**Re:** Response to the Reference Number:

8820, Confirmation Number: EA94132

| Title             | LOGIC BLOCK DIAGRAM FOR CNI-8100 |

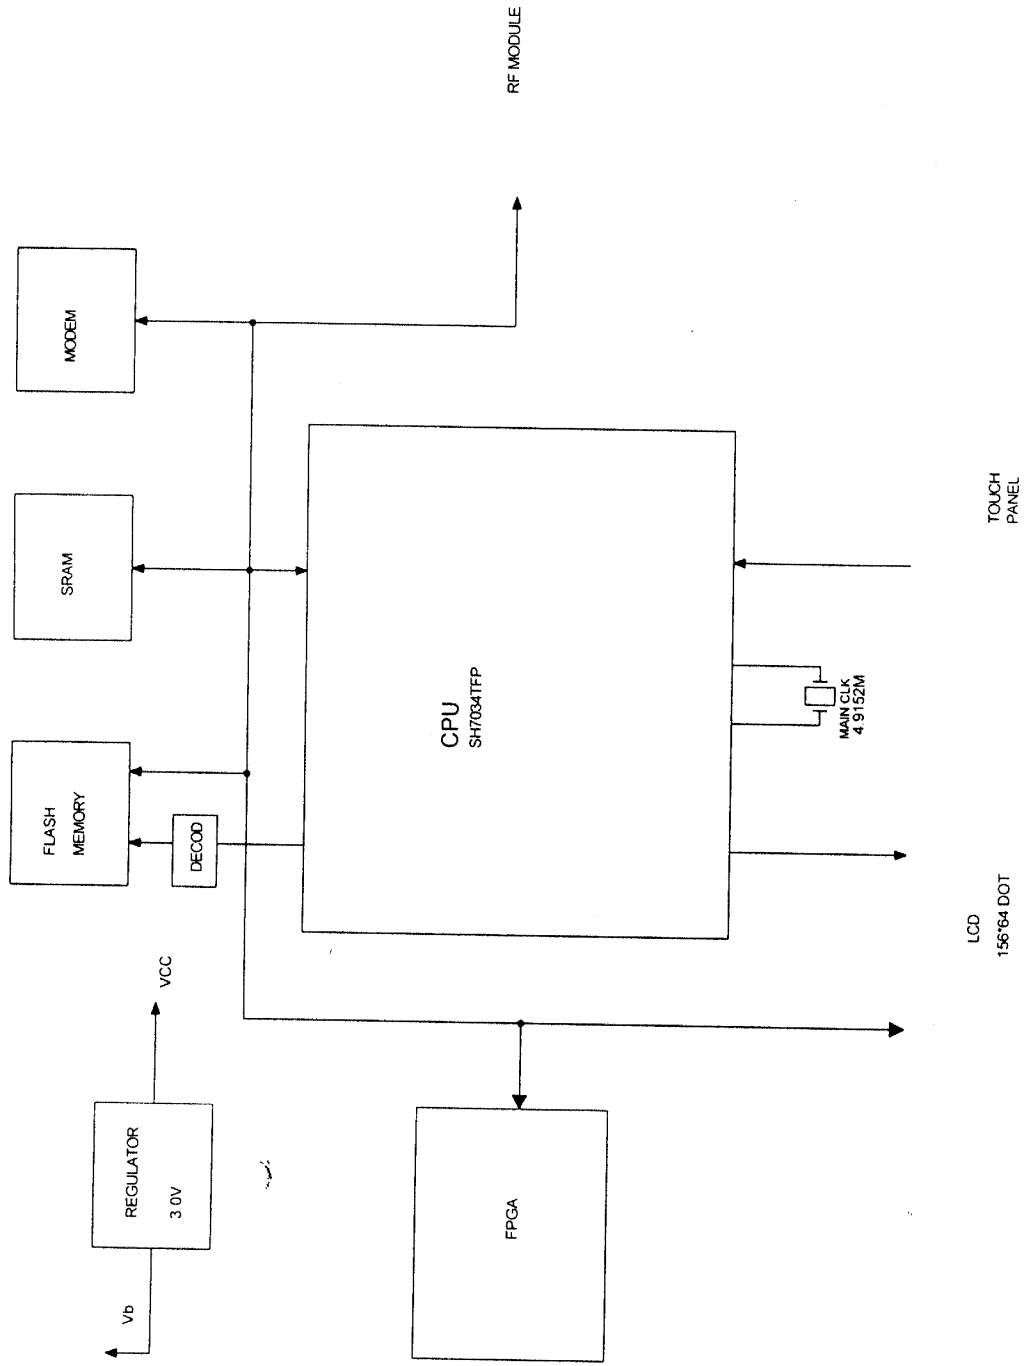
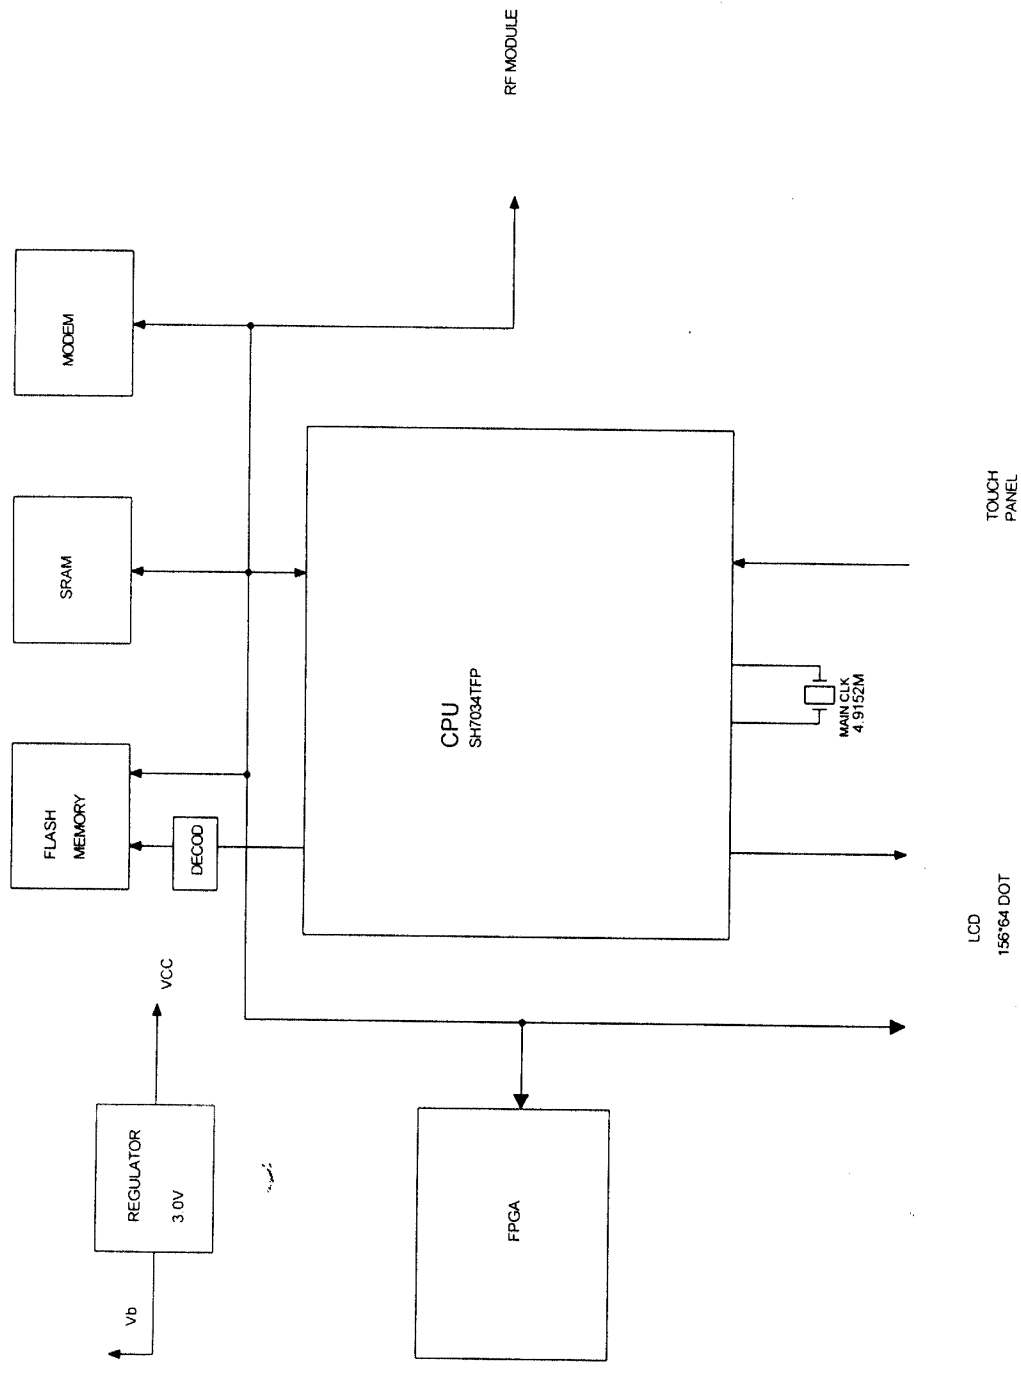
2) Please see the attached page for the schematics.
